SERVICE PARTS LIST FOR MITSUBISHI ELECTRIC PACKAGED AIR-CONDITIONERS

Series : PEFY-AF•CFM(R)

REVISED

Please change the old catalog (issued June 2009, No.BWE09030) to this new catalog.
Content of revision : Some of parts are changed.

BLOWER PARTS

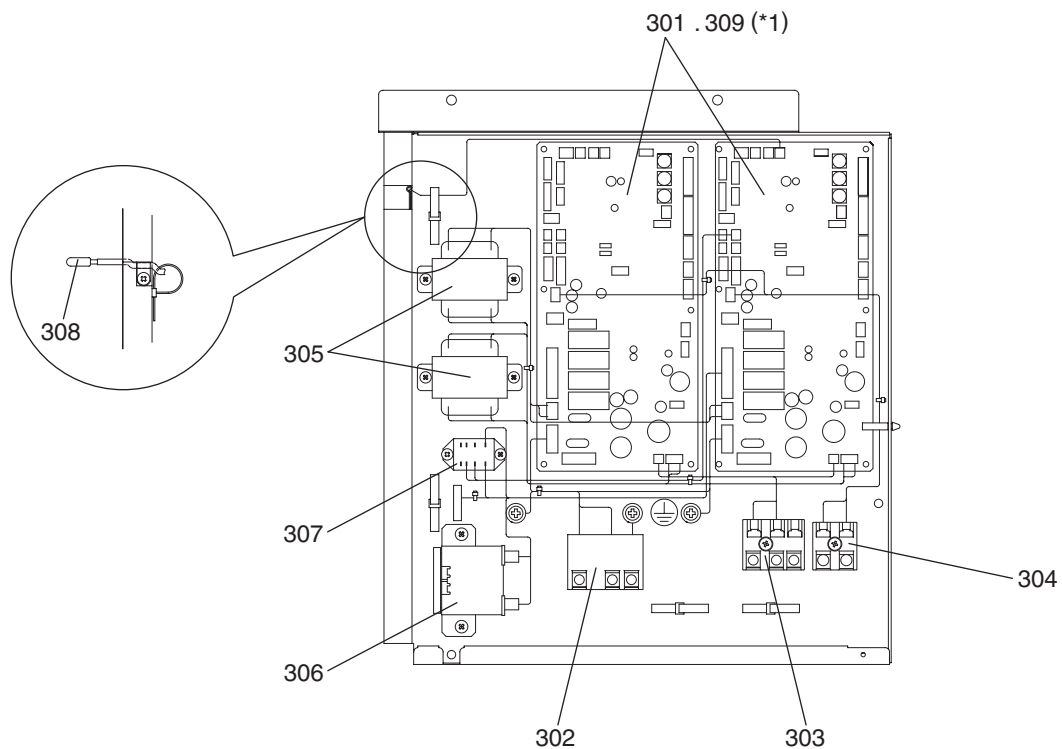
*1 For the products whose serial number is 2YW***** or later, be sure to use No. 309.
 For the products whose serial number is 2XW***** or earlier, both No. 301 and 309 can be used.
 No. 301 will be supplied as long as the stock is available,
 and only No. 309 will be supplied after the existing stock of No. 301 is depleted.

~2XW*****	2YW*****~
No.301	USE	NOT USE
No.309	USE	USE

CONTROL BOX PARTS (1)

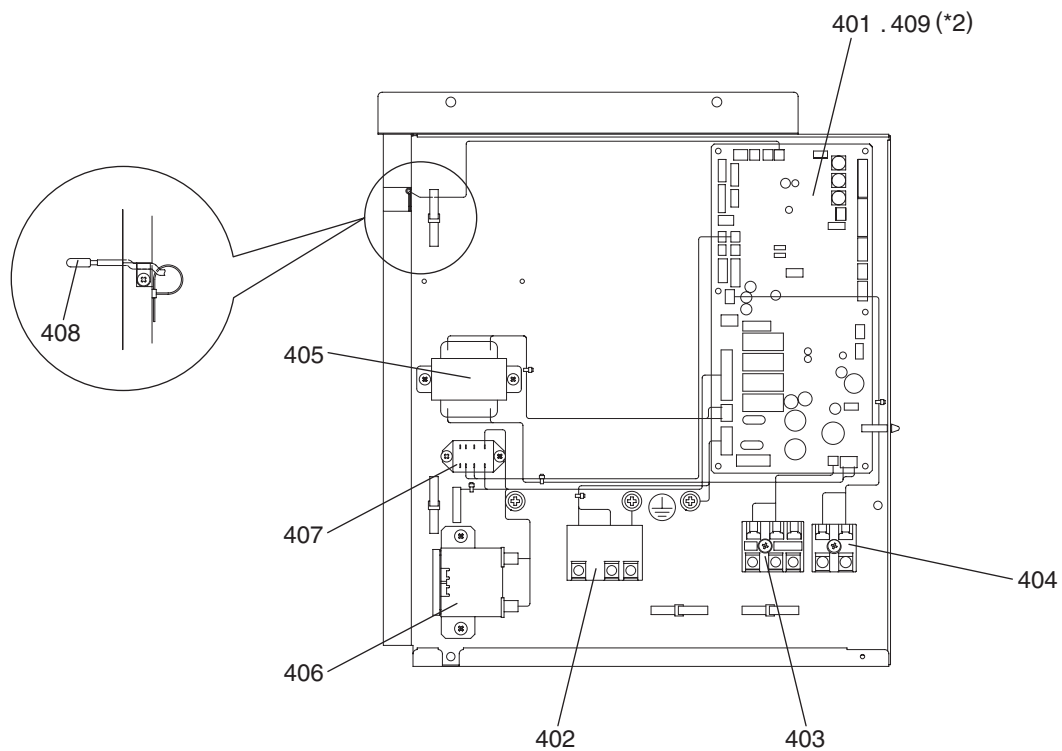
*2 For the products whose serial number is 2YW***** or later, be sure to use No. 409.
 For the products whose serial number is 2XW***** or earlier, both No. 401 and 409 can be used.
 No. 401 will be supplied as long as the stock is available,
 and only No. 409 will be supplied after the existing stock of No. 401 is depleted.

~2XW*****	2YW*****~
No.401	USE	NOT USE
No.409	USE	USE
